FROM STA. 28+50	TO STA. 28+79
PROJECT NAME	MONTPELIER
NO. MEGC-M6400 (7)	PLOTTED 05/04/87
SURVEYED BY	KASTNER-MOREAU 06/85
SHEET 182	OF 335 SHEETS

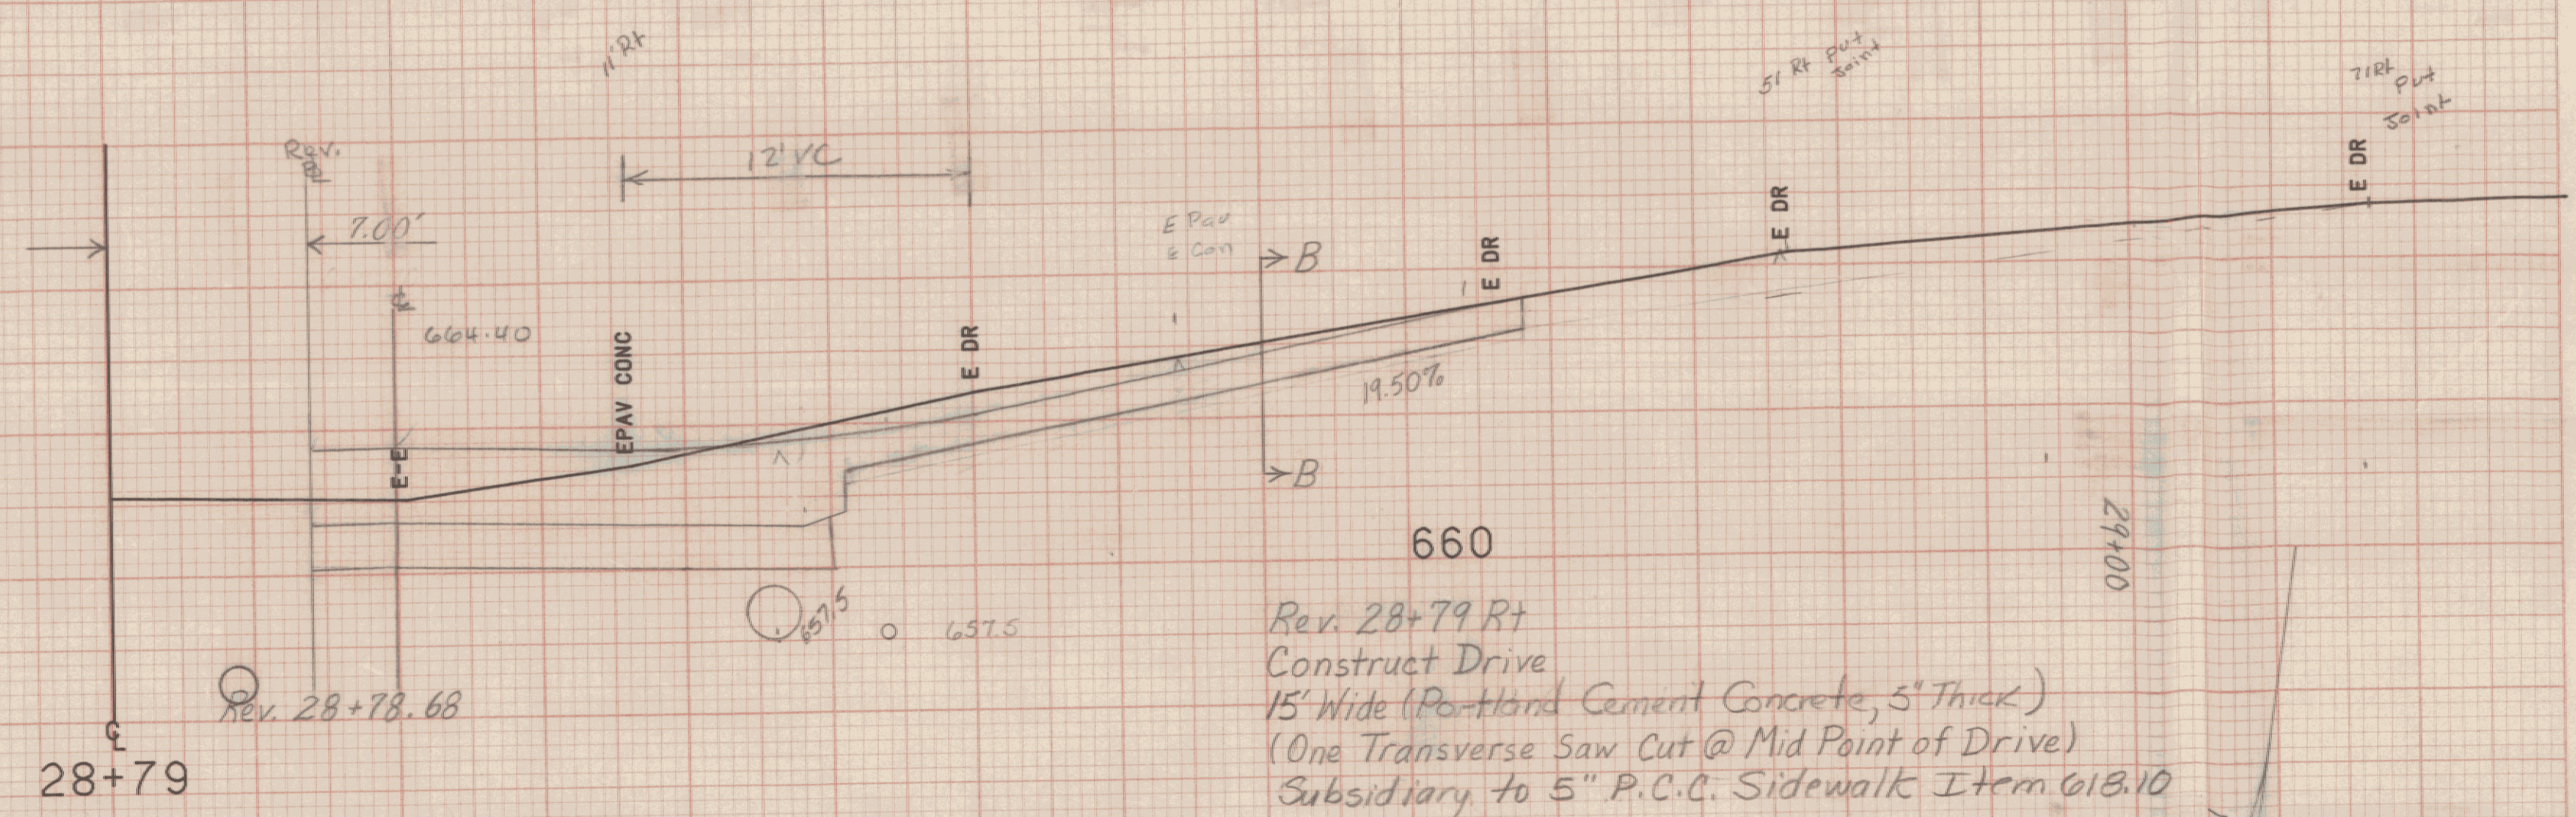
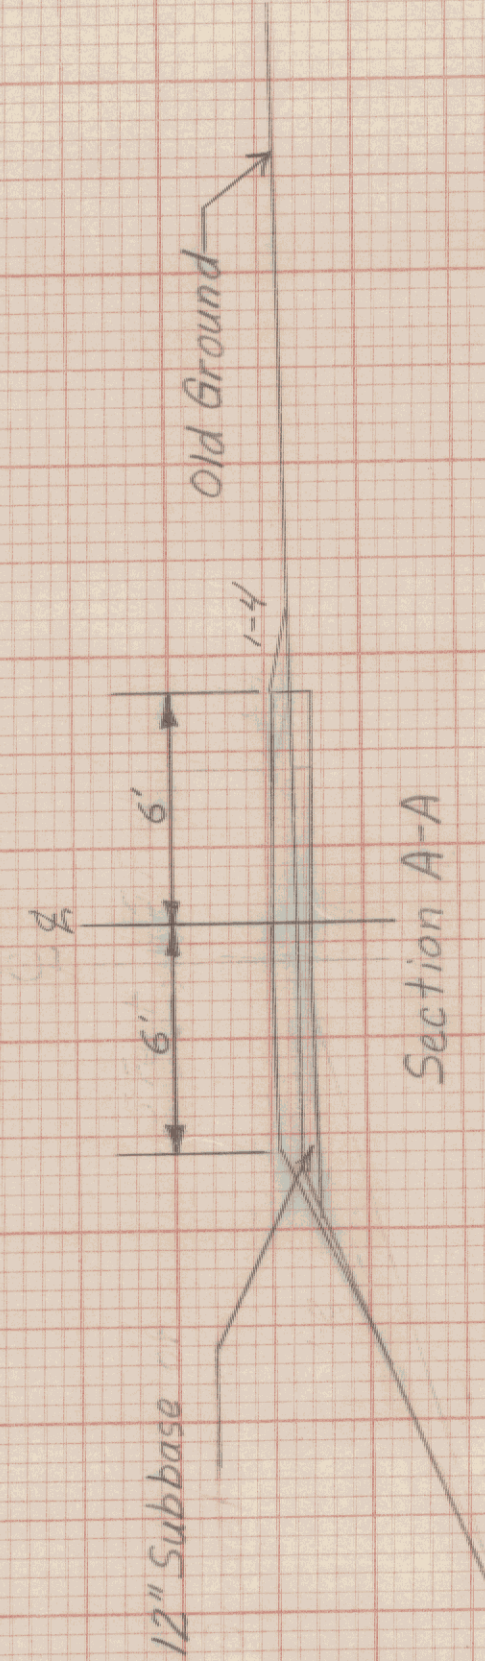
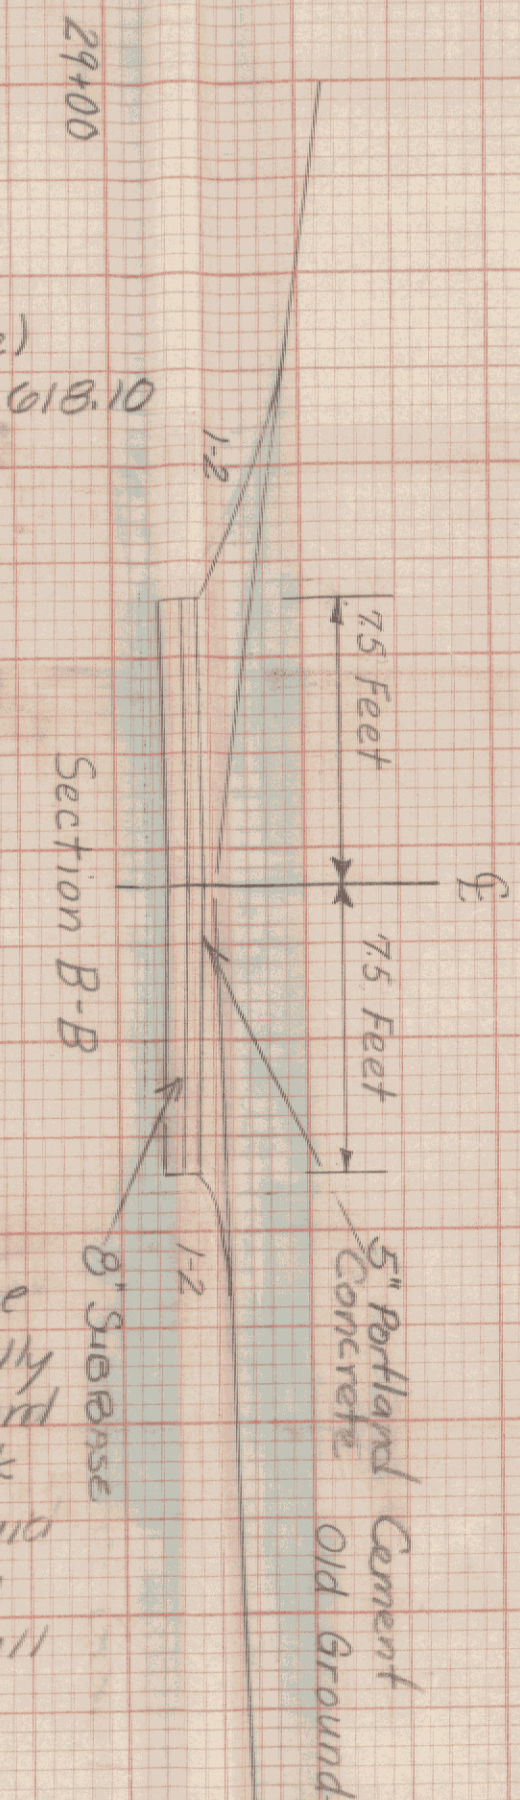
Rev. 28+78 Lt
Begin Vertical Granite Curb

Rev. 28+67 Lt
Construct Drive
12' Wide (Gravel)

Rev. 28+56 Lt
End Vertical Granite Curb

660
Rev. 28+79 Rt
Construct Drive
15' Wide (Portland Cement Concrete, 5" Thick)
(One Transverse Saw Cut @ Mid Point of Drive)
Subsidiary to 5" P.C.C. Sidewalk Item 618.10

Rev. 28+73 Rt.
End Vertical Granite Curb

660
Rev. 28+67 Rt
Remove & Reset Yard Light
The light will be relocated outside the City's R.O.W. Limits at a location mutually agreeable with the resident engineer and the property owner. The cost of work and necessary materials shall be paid under Item 679.25 (mod), removing and resetting light pole and shall be Non-Gov't. Participating.
